IN THE DRAWINGS:

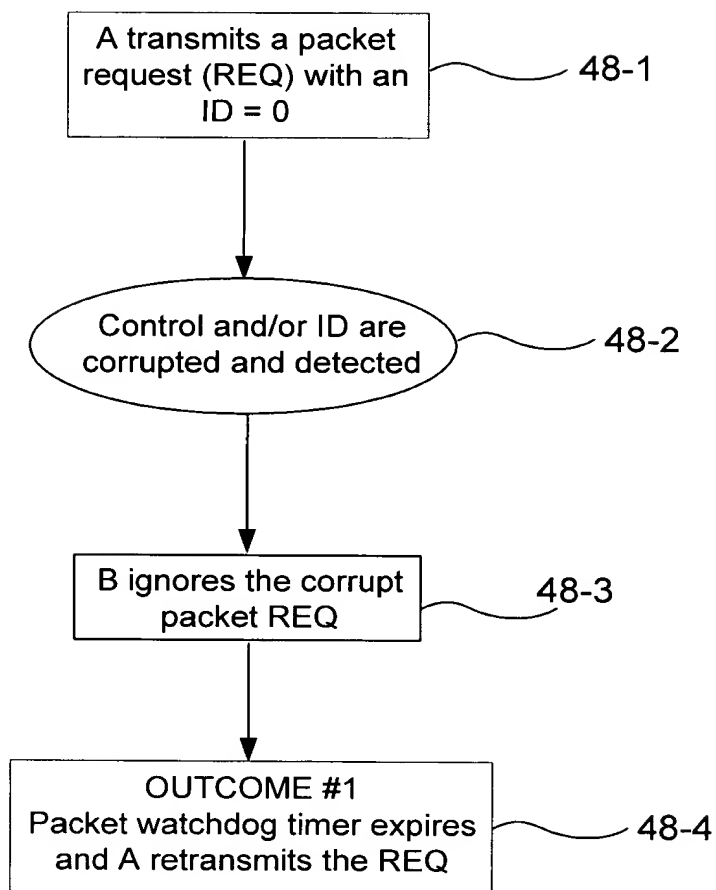
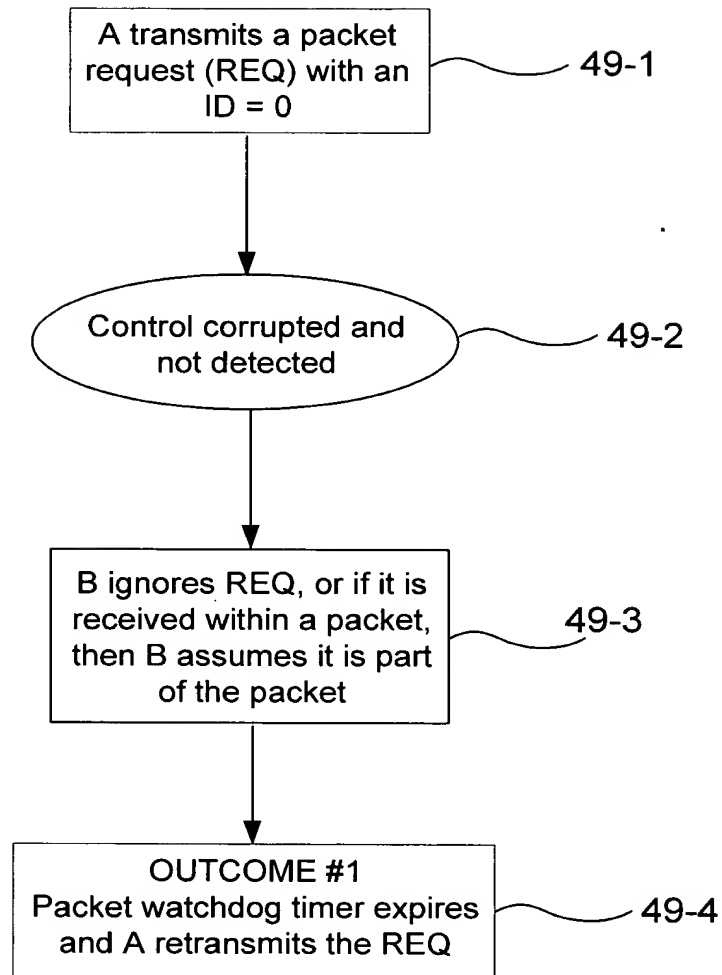
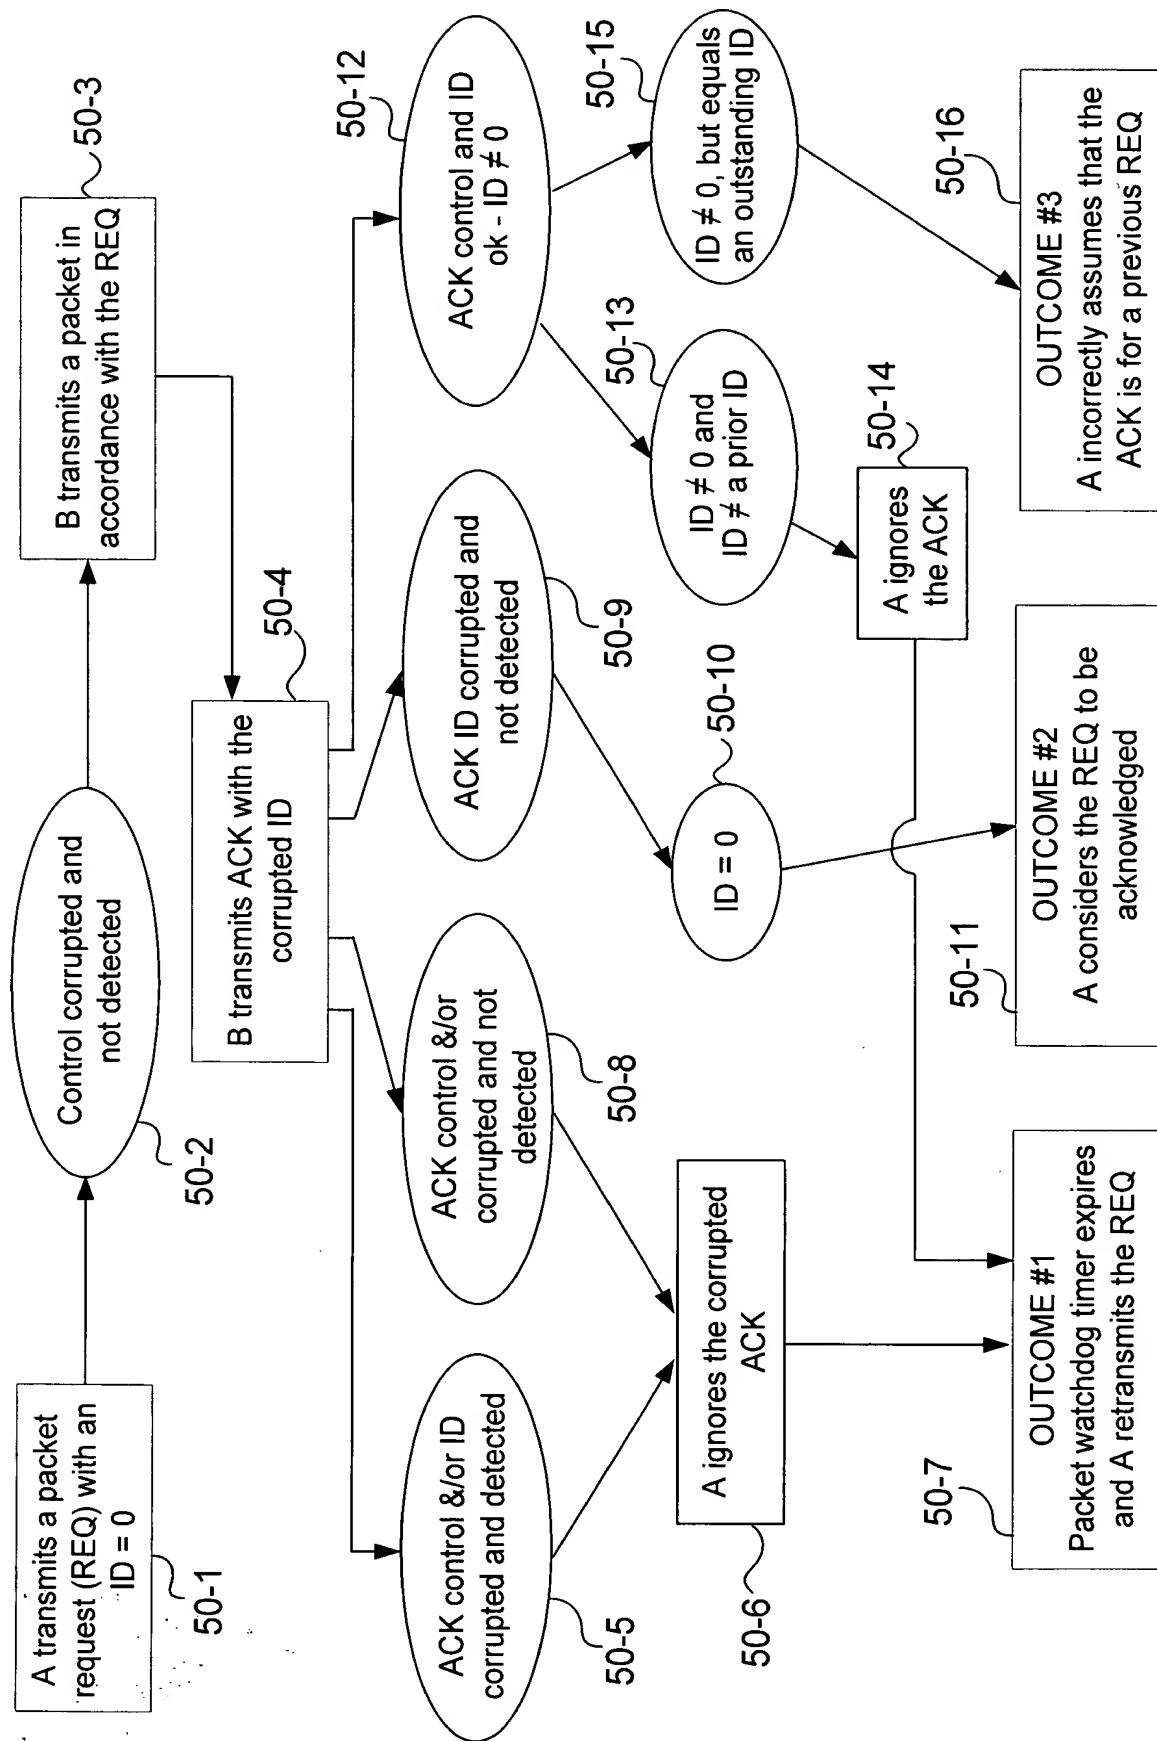
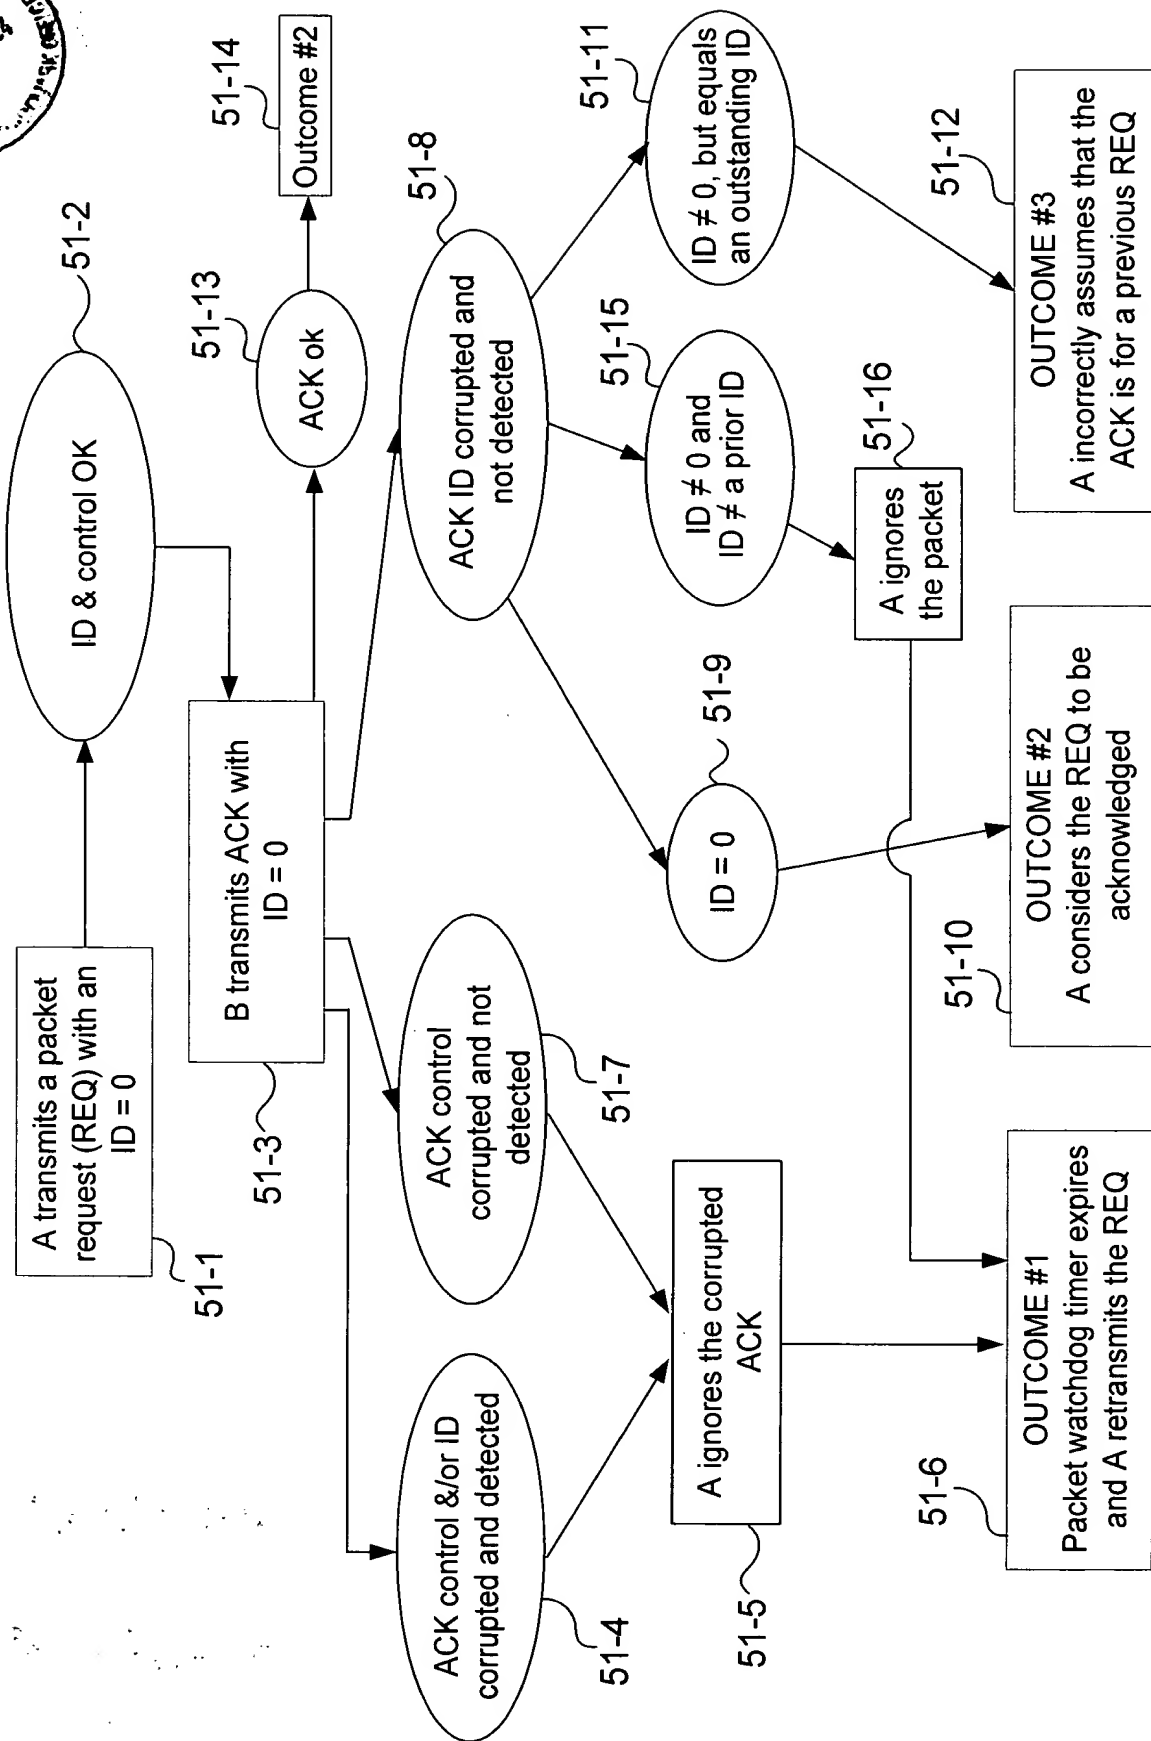
Please replace the original sheets containing Figs. 48-51 with the attached replacement sheet containing Figs. 48-51. The labeling was indicated as being handwritten and formal correction was requested by the Examiner.
